TRIANGLE DEALS, LLC  
"THE DRAIME"

PLAN NO.  
DK2618

Sheet No. **TRIANGLE DEALS, LLC**  
**THE DRAIME PLAN**

**SECOND FLOOR PLAN**  
SCALE: 1/4"=1'-0"  
8'-0" C.L.S. HGT.  
SET WINDOWS AT 6'-0" A.F.F.

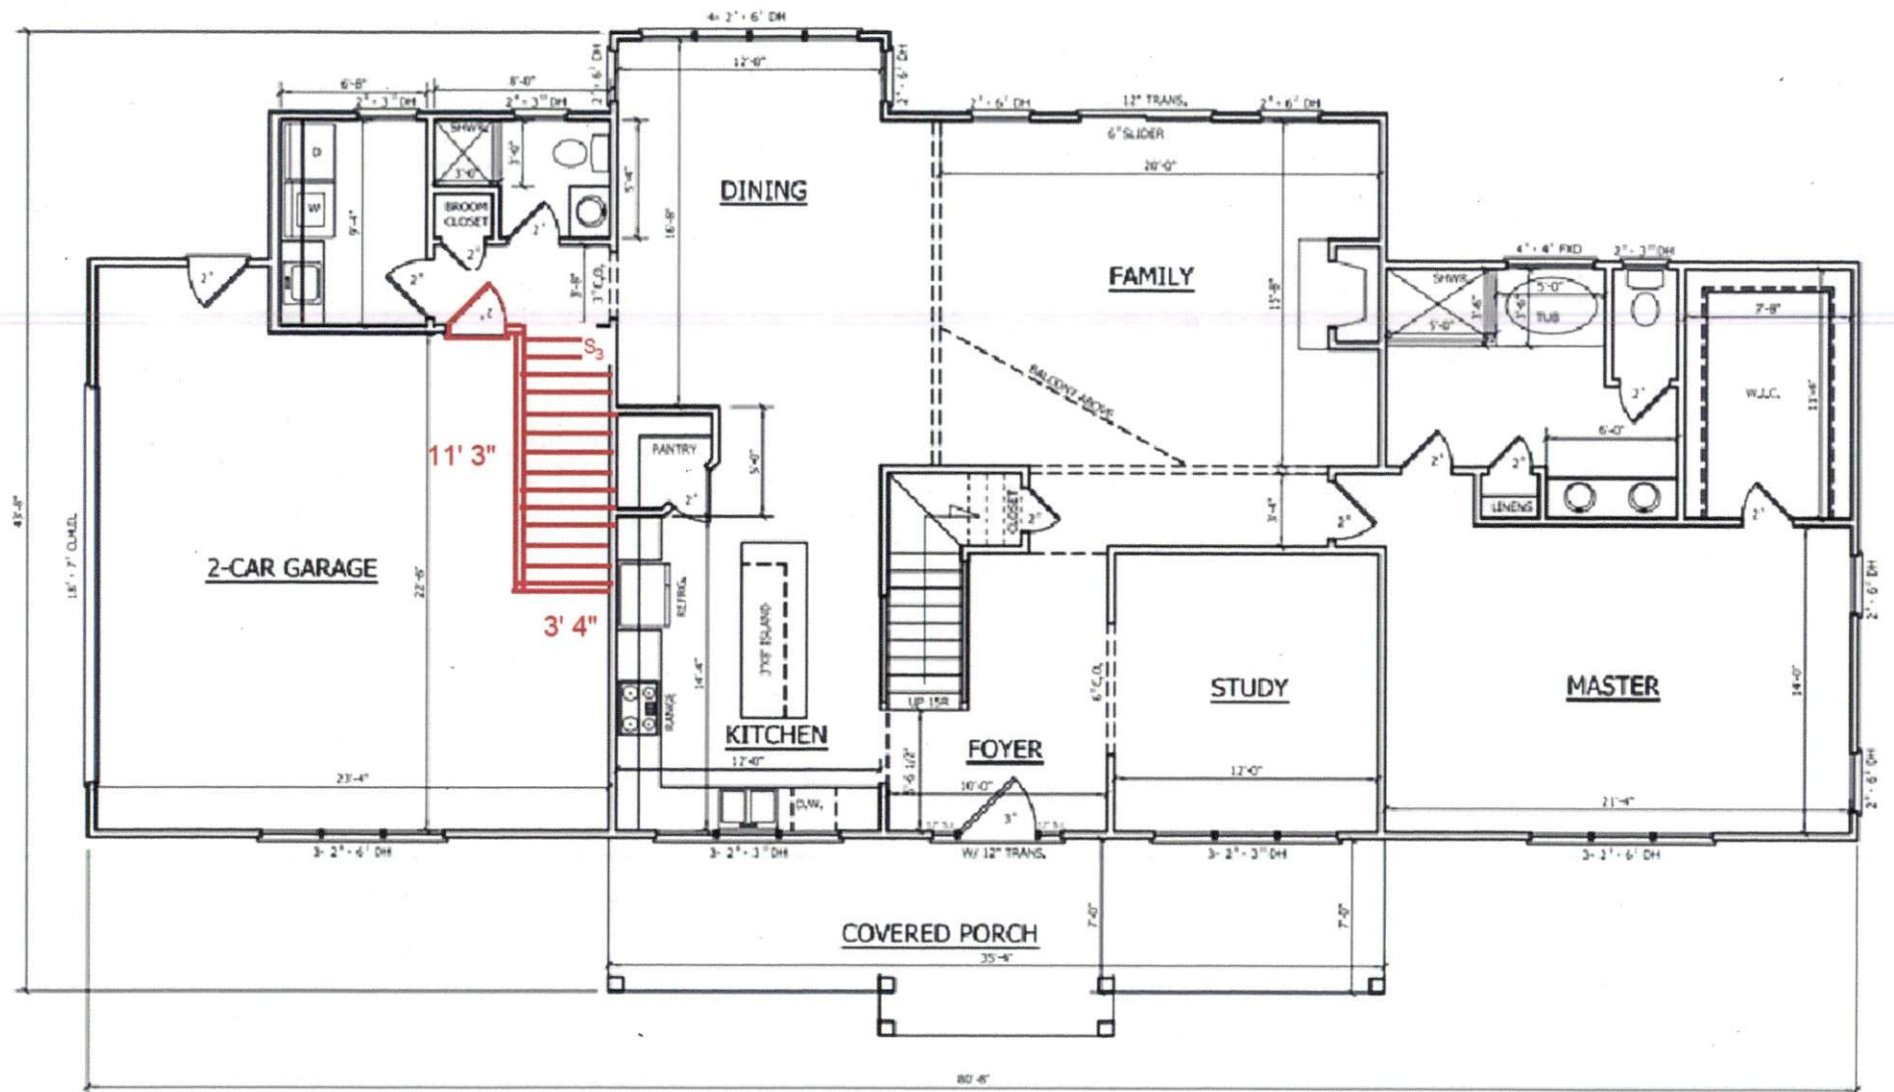
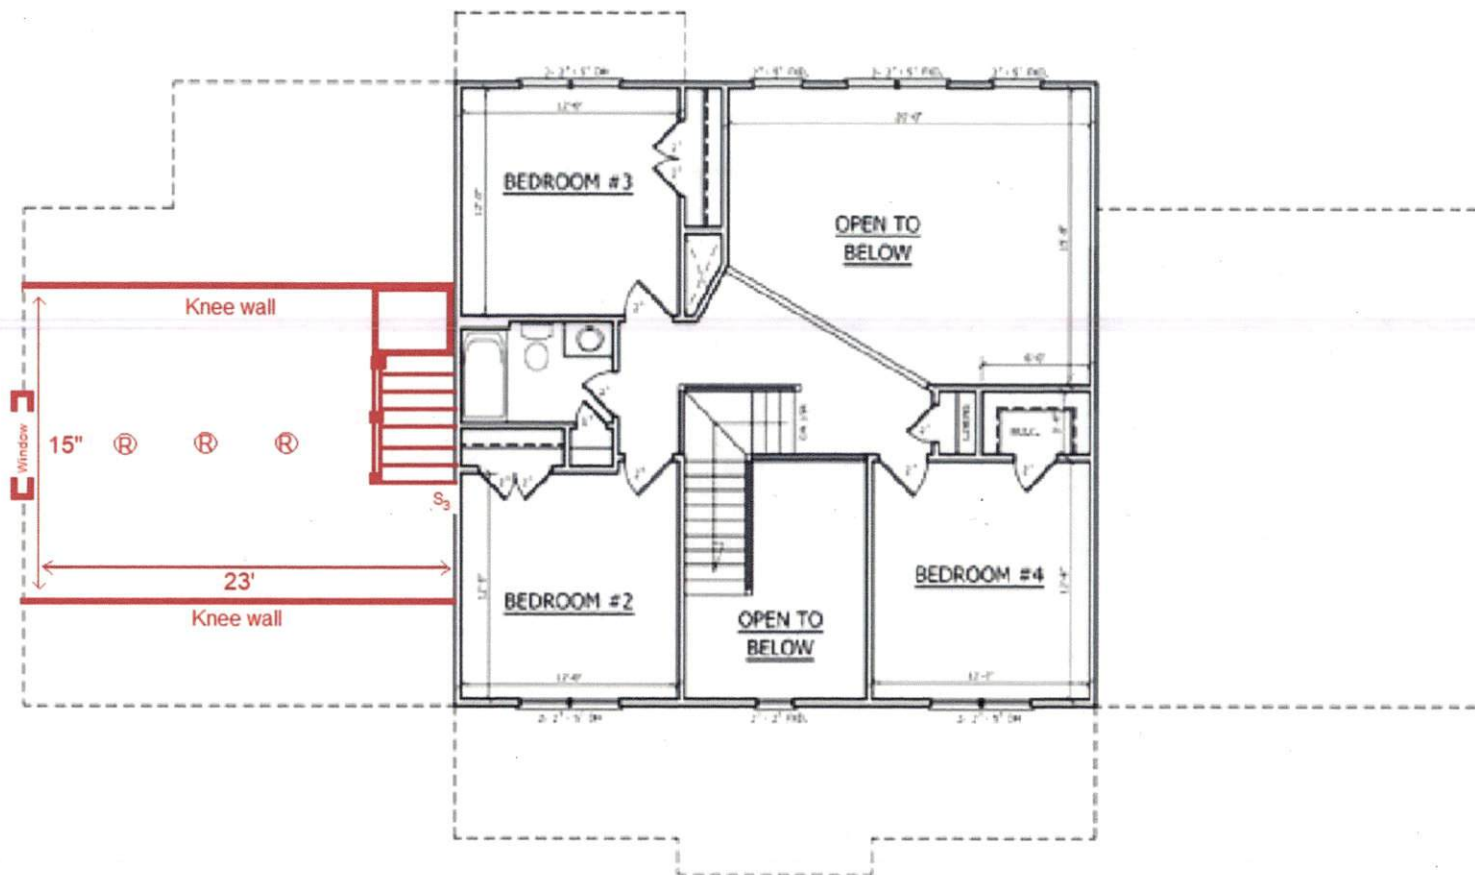
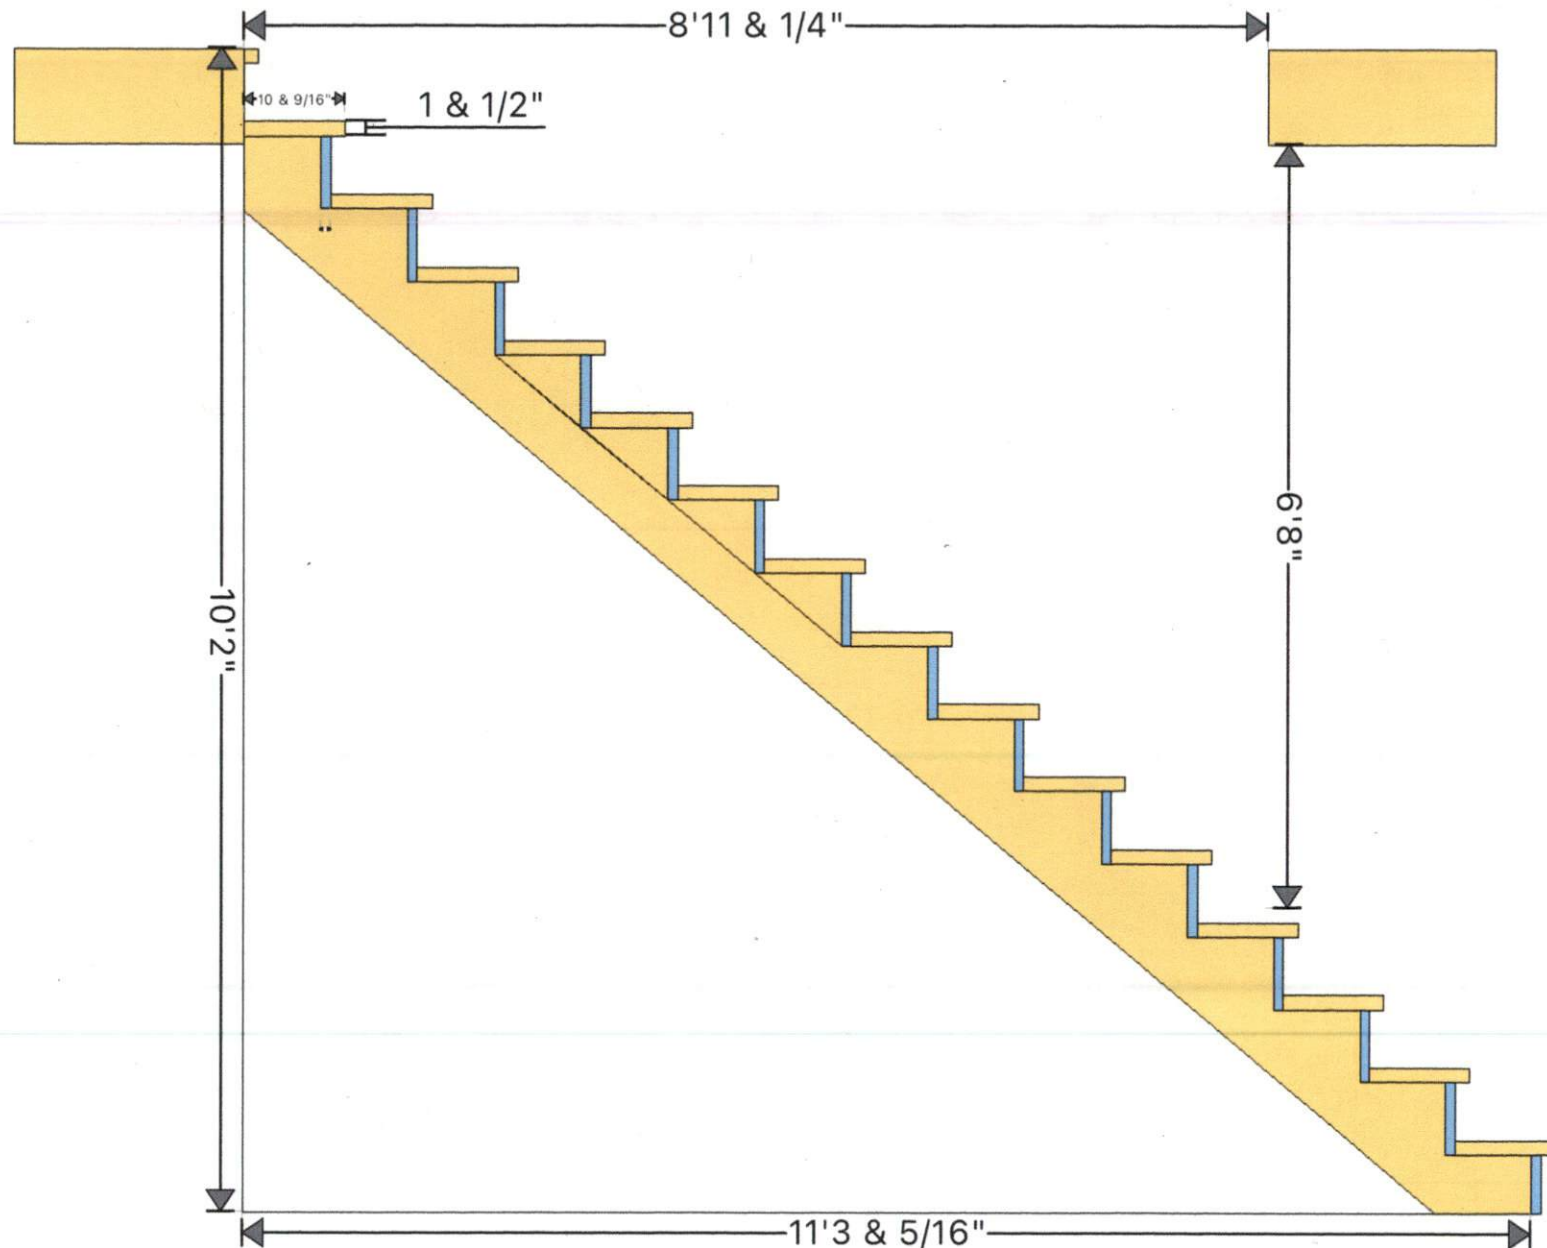
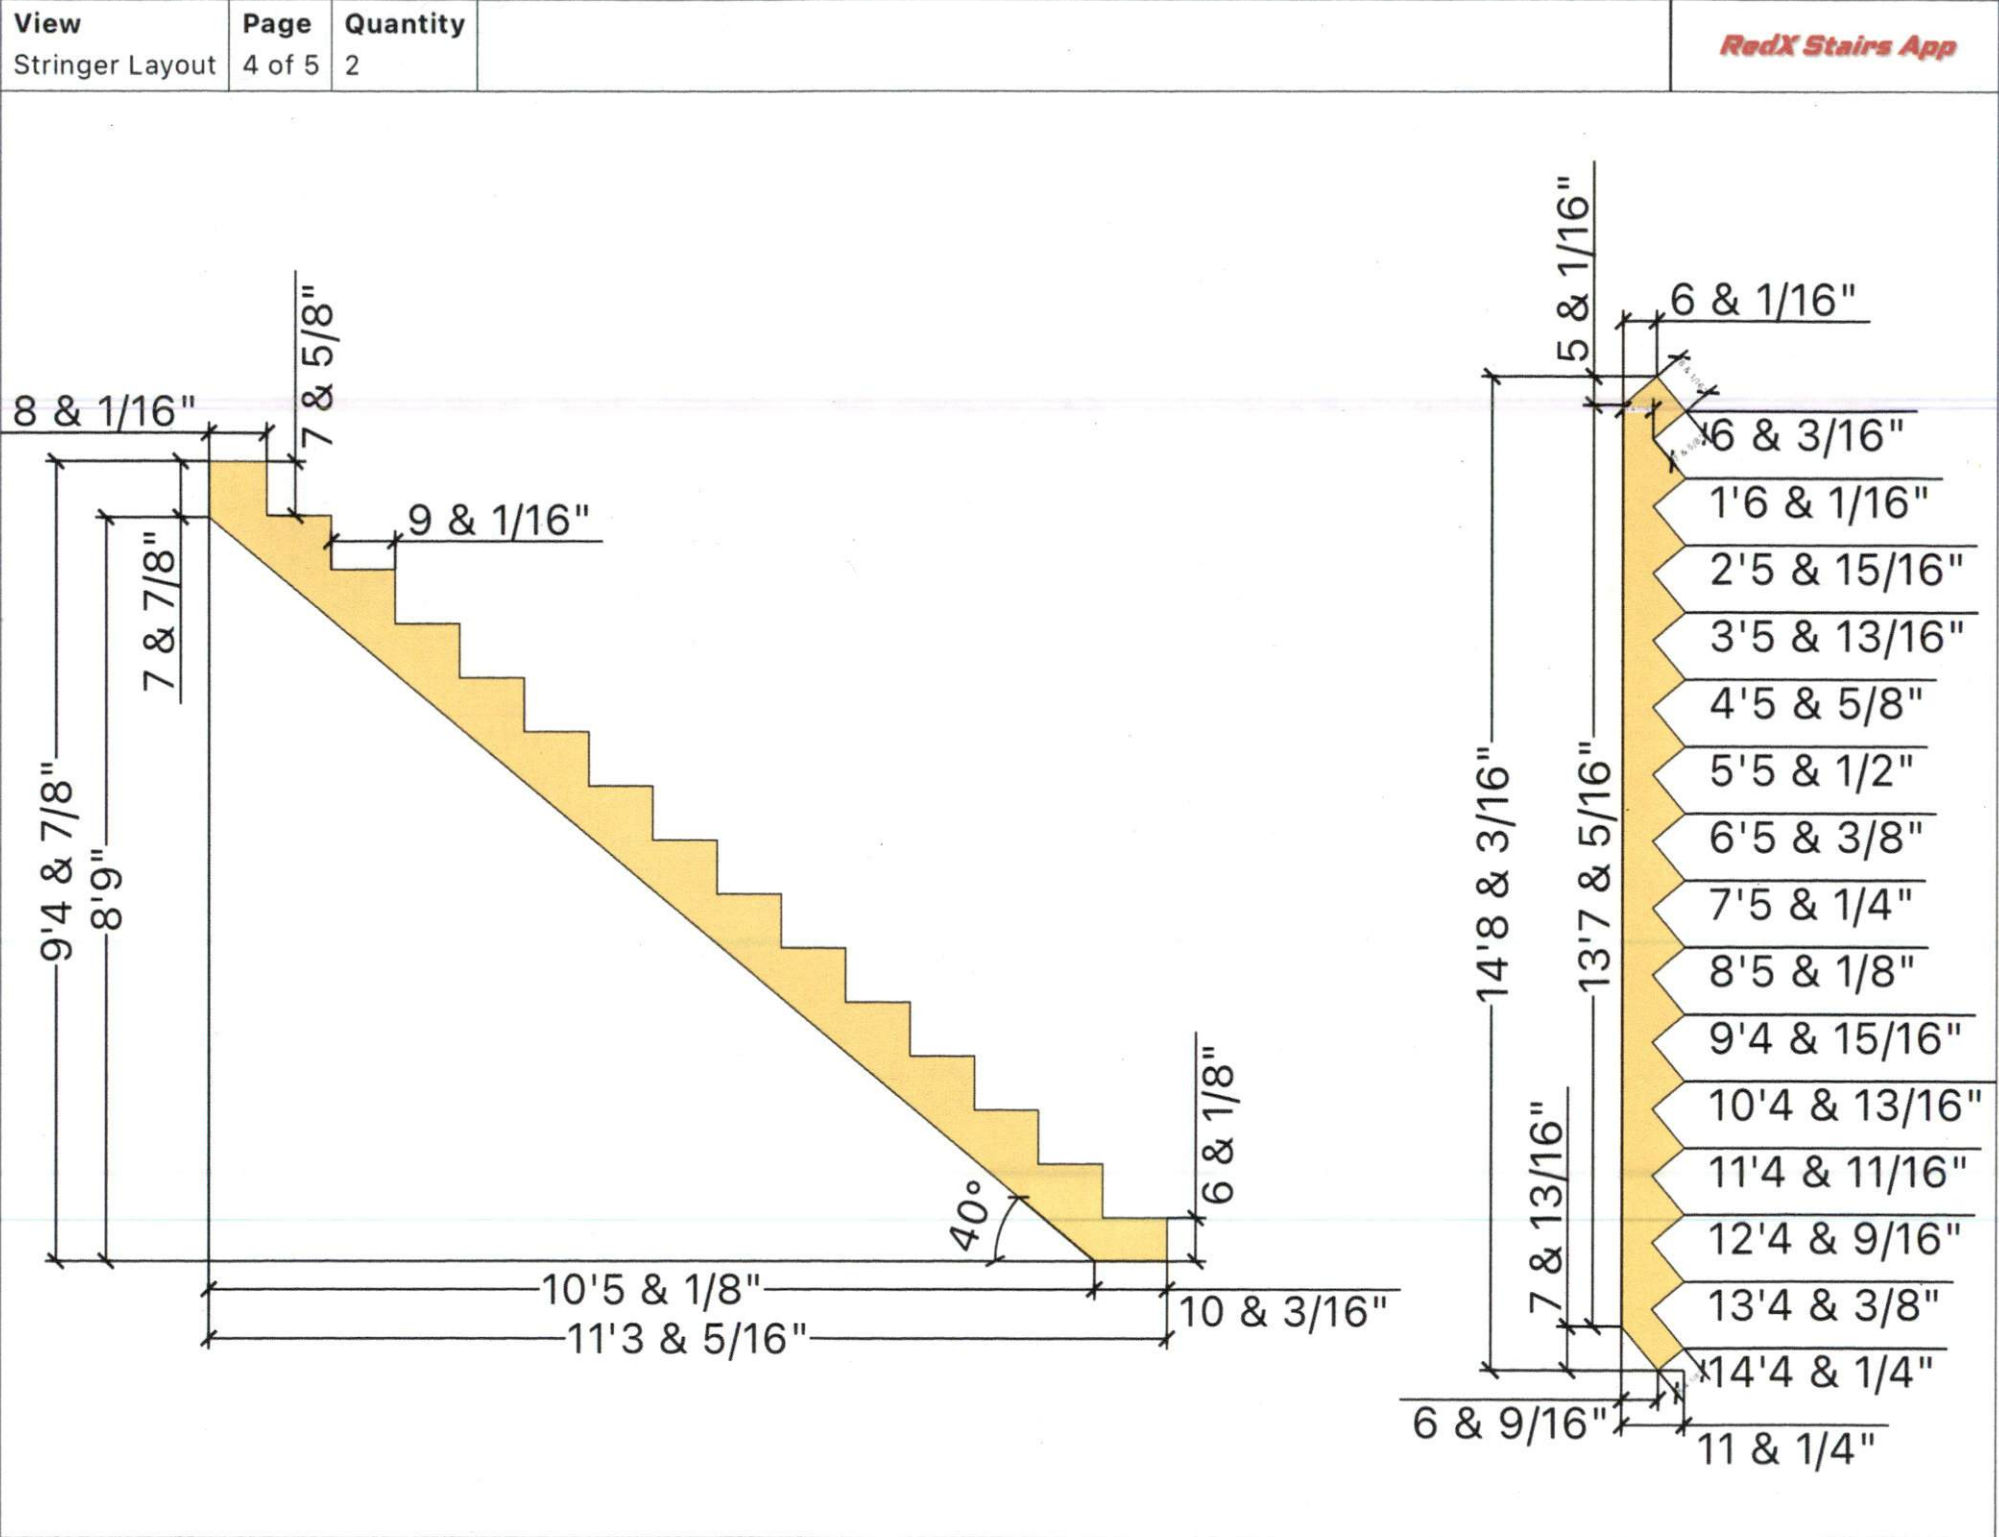
TJI Floor joist  
3'8"  
cut 2 TJI and  
header off  
for ac
